COMMITTEE OF THE WHOLE FEBRUARY 21, 2005

**SITE DEVELOPMENT FILE DA.04.073
2748355 CANADA INC.**

OPA 528 - Planned Road Network (Corporate Centre)

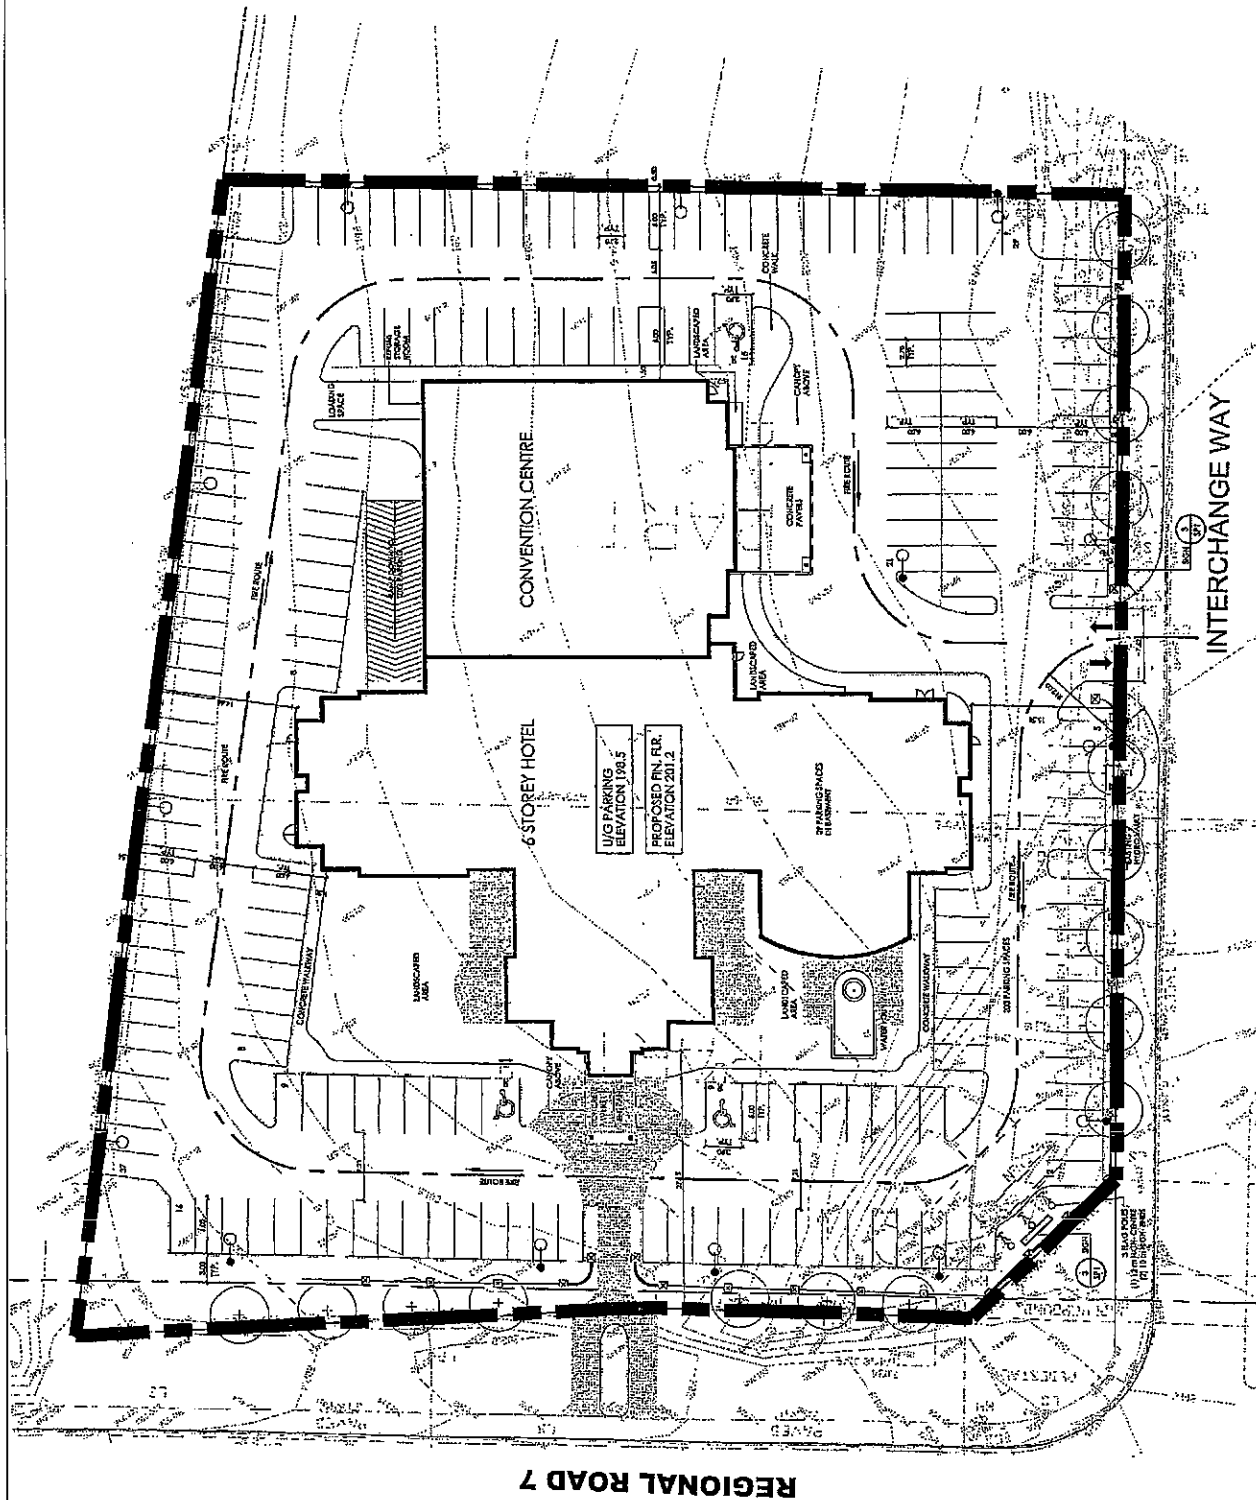
OPA #528 identifies specific road network improvements for the Corporate Centre Plan (Attachment #2). One of the elements of the plan includes a 100 m city block street system within a ring road. Two future roads, each having a planned width of 24m, are identified adjacent to the south and east property lines. To protect these future right-of-ways, there should be no

encroachments of any structural elements along respective property lines. The proposed building would not encroach into the future road locations.

The location of the proposed development relative to the planned road network for the Corporate Centre is shown on Attachment #2. OPA #528 identifies specific road network improvements serving the Vaughan Corporate Centre Area (OPA #500). An east/west road (parallel to Regional Road 7) is planned connecting Commerce Street to Jane Street and beyond, across the south

limit of the site plan. A north/south street is planned, connecting the ring road to the south of the site with Regional Road 7 to the north, just outside the east boundary of the site plan. The proposed building would not encroach into the planned roads.

Site Plan

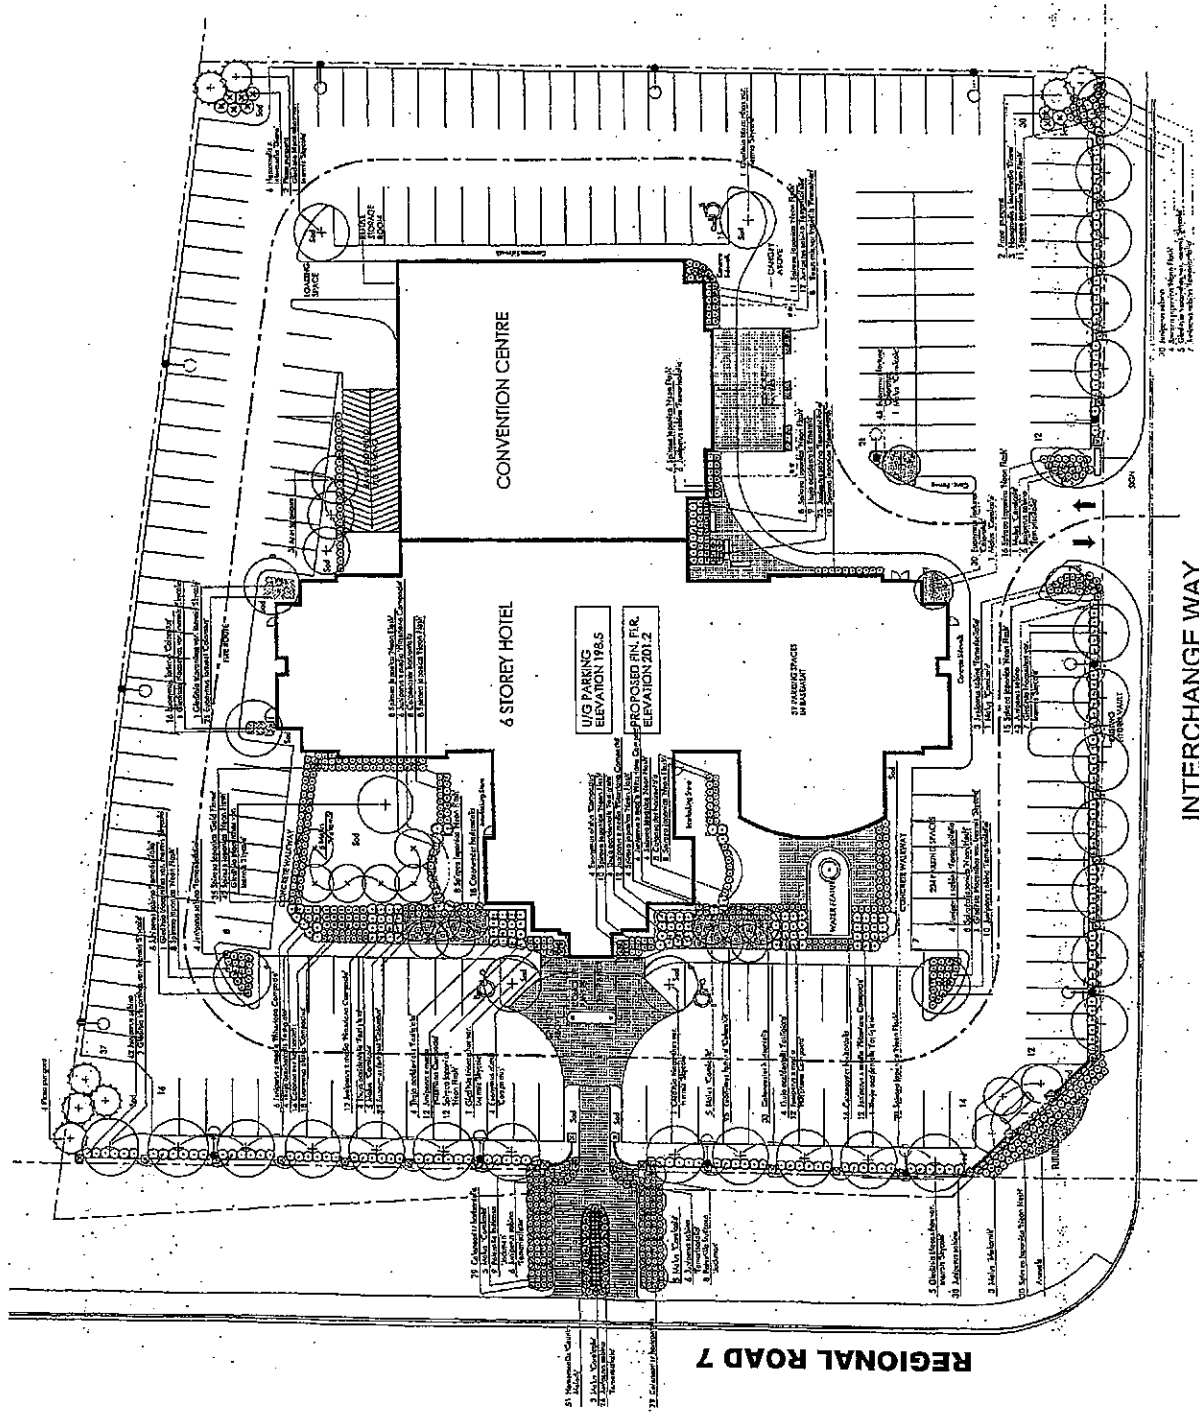
The site is subject to a build-to-zone provision, which requires 80% of the length of the street line to have a building located within 0-3 m of Regional Road 7, and 50% within 0-3m of Interchange Way. The proposed building is setback approximately 22m and 15m from Regional Road 7 and Interchange Way, respectively. The hotel requires vehicular circulation around the building, particularly for the customer drop-off area adjacent to Regional Road 7. This is an essential component for the hotel.

The Owner proposes one loading space for the entire development, which is located at the southeast corner of the convention center. By-law 1-88 requires four loading spaces for a commercial use with more than 10,001m² of gross floor area. The Owner has indicated that only one loading space is required to service the development. Staff has no objection to reducing the number of loading spaces, particularly in the context of the Corporate Centre location, which is a highly visible location.

The Owner proposes 39 parking spaces underground. The proposed parking space dimension for 11 of the parking spaces is 2.55m x 5.9m, whereas the by-law requires a minimum of 2.7m x 6m. The City Engineering Department must be satisfied with on-site vehicular circulation.

The site plan (Attachment #3) shows a six-storey hotel facing Regional Road 7, with an attached one-storey convention centre and second storey ancillary offices above, facing Interchange Way. The site is to be served by one full access on Interchange Way. There is vehicular circulation with parking around the building, and additional underground parking is proposed. Landscaping and pedestrian walkways are proposed around the building with a connection to Regional Road 7. A water feature and landscaping are proposed in large landscaped areas on both sides of the building's main entrance.

1. THAT Site Development File DA.04.073 (2748355 Canada Inc.) BE APPROVED, for a 6 storey hotel (Hilton-150 rooms) and convention centre with ancillary offices, as shown on Attachment #3, subject to the following conditions:

The Owner will be required to obtain the above-noted variances, to the built-to-zone, landscape strip widths, the minimum number of loading spaces required, and parking space dimensions, from the Committee of Adjustment, which shall be final and binding as a condition of site plan approval.

Landscape Plan

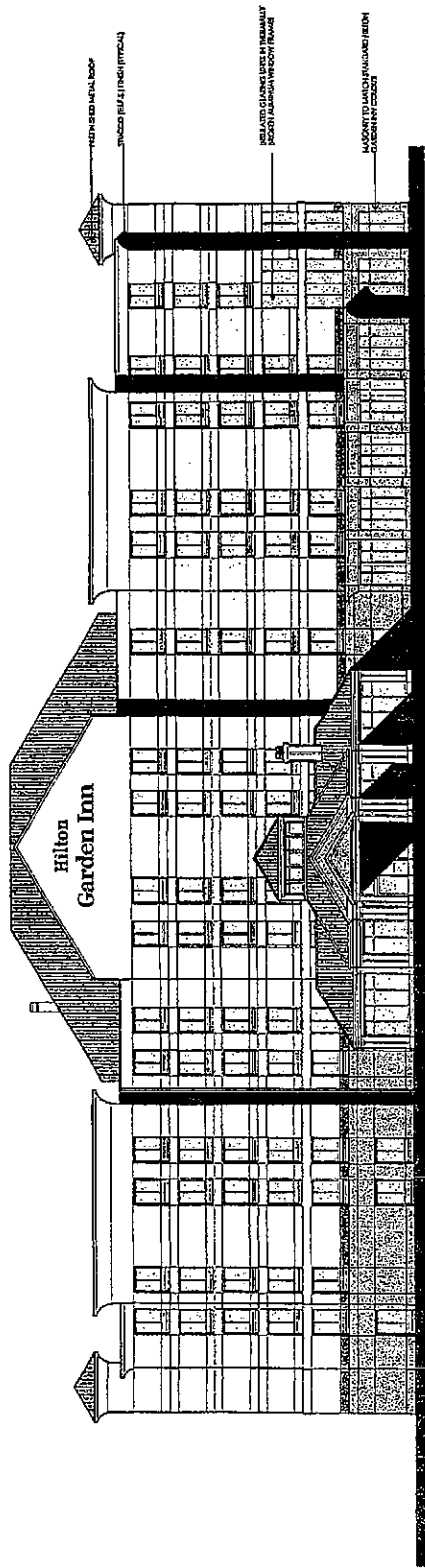
In a C9 Zone, By-law 1-88 requires a minimum 6 m wide landscape strip to be provided along Regional Road 7, and a 3m wide landscape strip adjacent to Interchange Way. The Owner will be required to convey lands along Regional Road 7 to the Region of York for road widening purposes. Once the lands are conveyed, a 3m wide landscape strip will be provided. A 1.3m wide landscape strip is proposed along Interchange Way. Staff has no objections to the reduced landscape strips, given the additional landscape treatment proposed by the Owner, as described in this report and as shown on the landscape plan on Attachment #4.

The proposed landscape plan (Attachment #4) shows perimeter planting along Regional Road 7 and Interchange Way consisting primarily of deciduous trees and coniferous shrubs, together with

a 2.4 m high wall/fence constructed with masonry pillars and decorative solid steel pickets. A wide pedestrian walkway of concrete pavers is proposed between the building's main (north) entrance and extending into the Regional Road 7 right-of-way. A concrete walkway extends along most of the building's perimeter. Large landscaped areas containing planting, pavers, and a water feature, are proposed on both sides of the main entrance facing Regional Road 7. Pavers and planting are also proposed at the entrance to the convention centre facing Interchange Way. A corporate sign, measuring 2m high, 3.7m long and 0.6m wide, is proposed within the landscape strip at the intersection of Regional Road 7 and Interchange Way. Similarly, an entrance sign, measuring 1.5m high, 3.1m long and 0.45m wide, is proposed within the landscape strip where the driveway intersects with Interchange Way. Pole mounted lighting is proposed along the site's perimeter.

The final landscape plan, including detail drawings and a landscape cost estimate, must be approved to the satisfaction of the Development Planning Department. The proposed landscape elements within the Regional Road 7 right-of-way must be approved to the satisfaction of the Region of York Transportation and Works Department.

Elevations

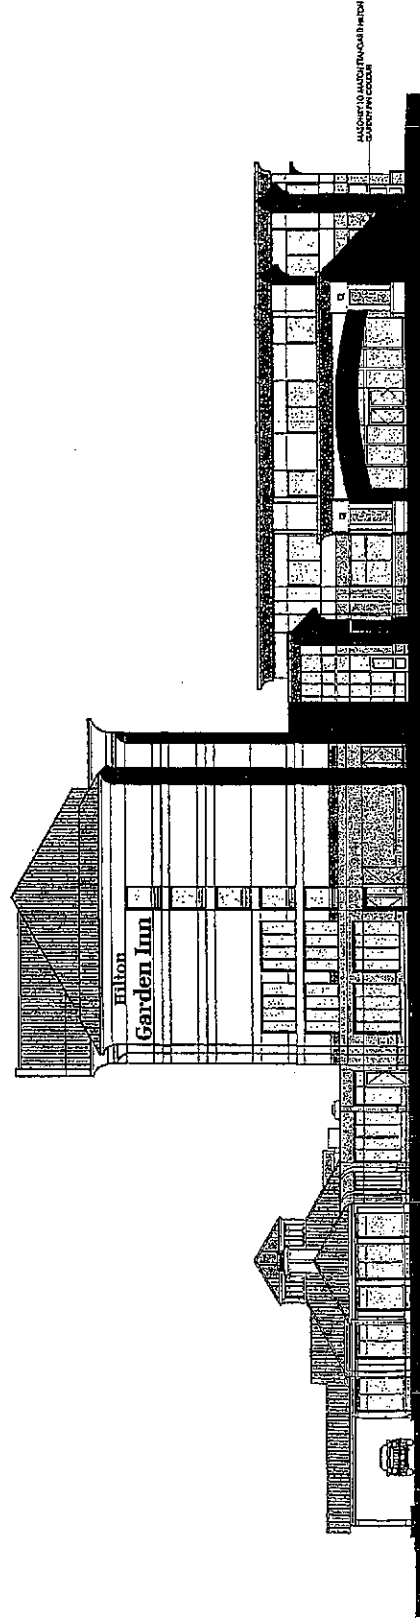
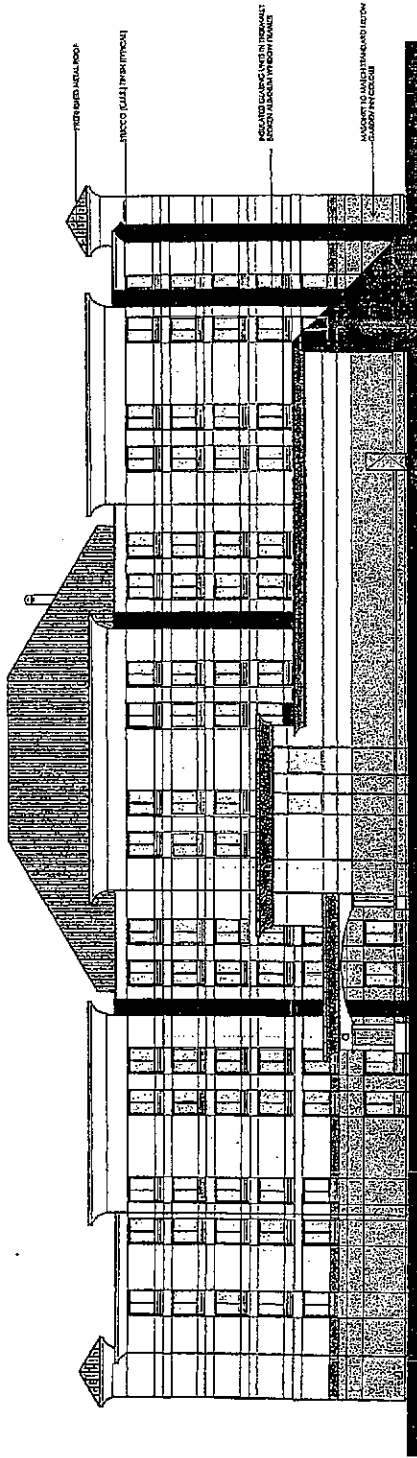
The proposed building elevations are shown on Attachments #5 and #6. The hotel is 6-storeys high with a one-storey main entrance/lobby and covered canopy extending out front and facing Regional Road 7. The convention centre with second storey offices is integrated behind the hotel, with its main entrance and covered canopy facing Interchange Way. There is a considerable amount of glazing at the main entrances, and on the first and second floor levels of the building that face the adjacent roads. The building material consists of stucco. The first floor is a brown/tan colour, with a lighter tone used between floors 2 to 5, and a white colour is used for the top floor. The roofline is a combination of a flat-corniced roof and a pitched green metal roof. Signage is proposed on the top storey of the hotel, facing Regional Road 7 and Interchange Way.

As a condition of site plan approval, the final building elevations shall be to the satisfaction of the Development Planning Department.
